Local Planning Panel 1 July 2020

274-276 Glebe Point Road, Glebe

D/2019/1470

- adaptive reuse of existing building
- change of use to 100 room boarding house
- including managers room, basement parking and roof top "urban farm"

height

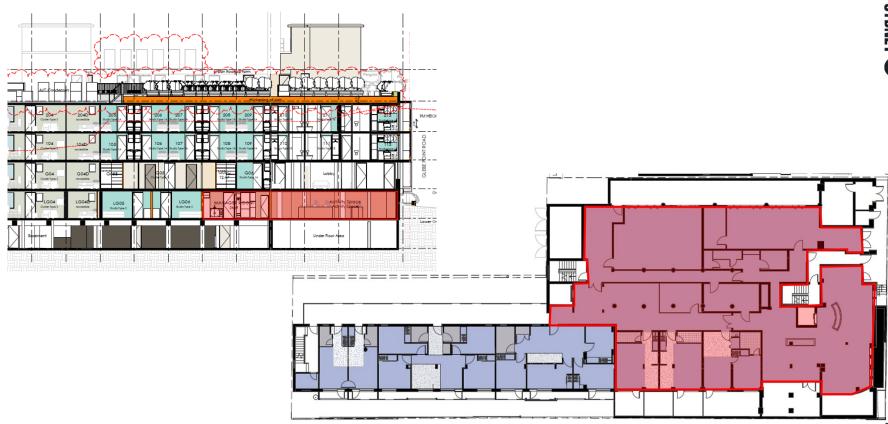
- Clause 4.6 variation request submitted
- non-compliance with height results from plant and roof top structures
- all new works will be a maximum of 17.3m, below the existing maximum building height of 20.5m
- new works will not result in increased overshadowing and bulk has been mitigated where possible
- height variation is supported

existing and proposed Glebe point Road elevation

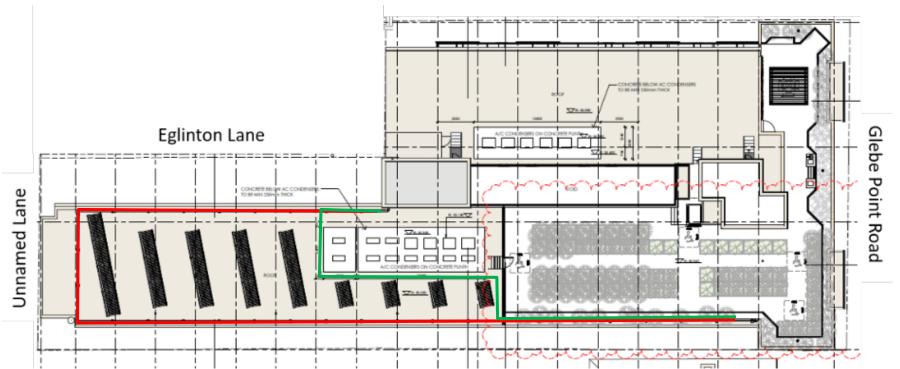
- facade upgrades proposed
- proposed changes seek to improve the facade however a number of elements could be refined:
 - rendering of the Glebe Point Road portion of the building is not required
 - awning at the top of the front facade to be retained

proposed eastern elevation

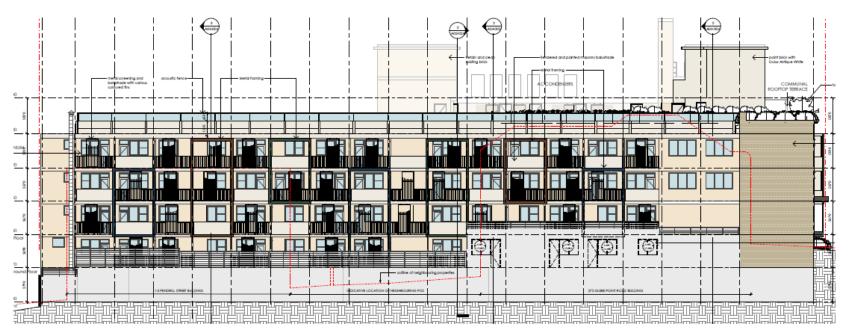
east and west facades include balconies and open corridors which are to be retained

typical privacy screen

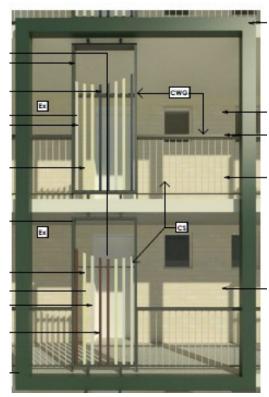
- screening proposed is not considered adequate
- the following has been recommended to mitigate concerns:
 - green screening on western facade corridors
 - improved balustrading to corridors
 - full height screens to balconies
 - use of rooftop restricted to 7am-10pm
